UNITED STATES PATENT AND TRADEMARK OFFICE

APPLICATION NO.	FILING DATE	FIRST NAMED INVENTOR	ATTORNEY DOCKET NO.	CONFIRMATION NO.
10/579,067	05/22/2007	Yasushi Kobuchi	2691-000044/US	1571

Office Action Summary	Application No. 10/579,067	Applicant(s) KOBUCHI ET AL.	
	Examiner CLAIRE L. ROE	Art Unit 1727

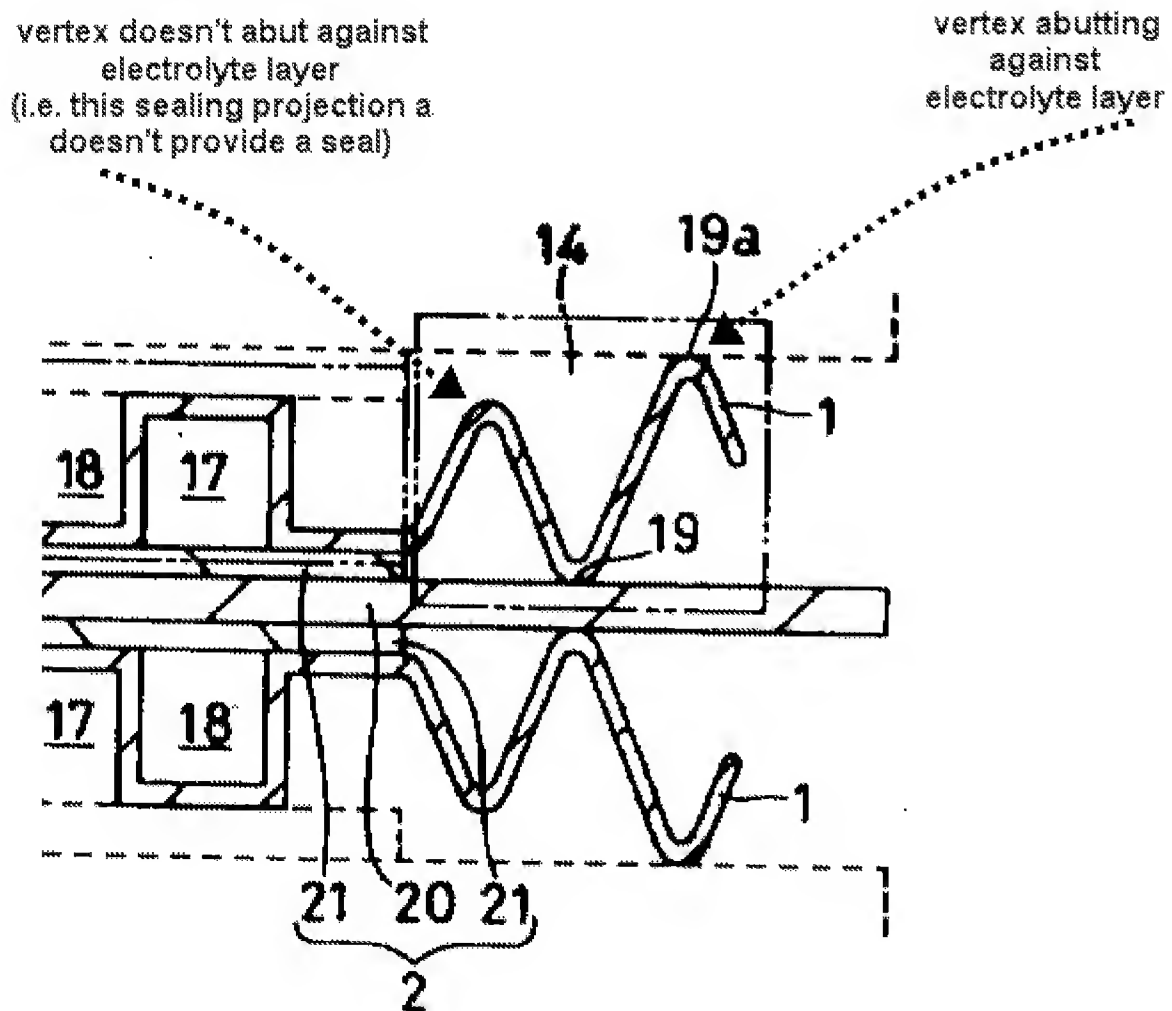
2. The drawings are objected to under 37 CFR 1.83(a). The drawings must show every feature of the invention specified in the claims. Therefore, the vertices (see claim 9 & 19a of Figure 2) of the sealing projections abutting against the electrolyte layer must be shown or the feature(s) canceled from the claim(s). No new matter should be entered. The following illustration (modified instant Figure 2) is provide for clarification:

Corrected drawing sheets in compliance with 37 CFR 1.121(d) are required in reply to the Office action to avoid abandonment of the application. Any amended replacement drawing sheet should include all of the figures appearing on the immediate prior version of the sheet, even if only one figure is being amended. The figure or figure number of an amended drawing should not be labeled as "amended." If a drawing figure is to be canceled, the appropriate figure must be removed from the replacement sheet, and where necessary, the remaining figures must be renumbered and appropriate
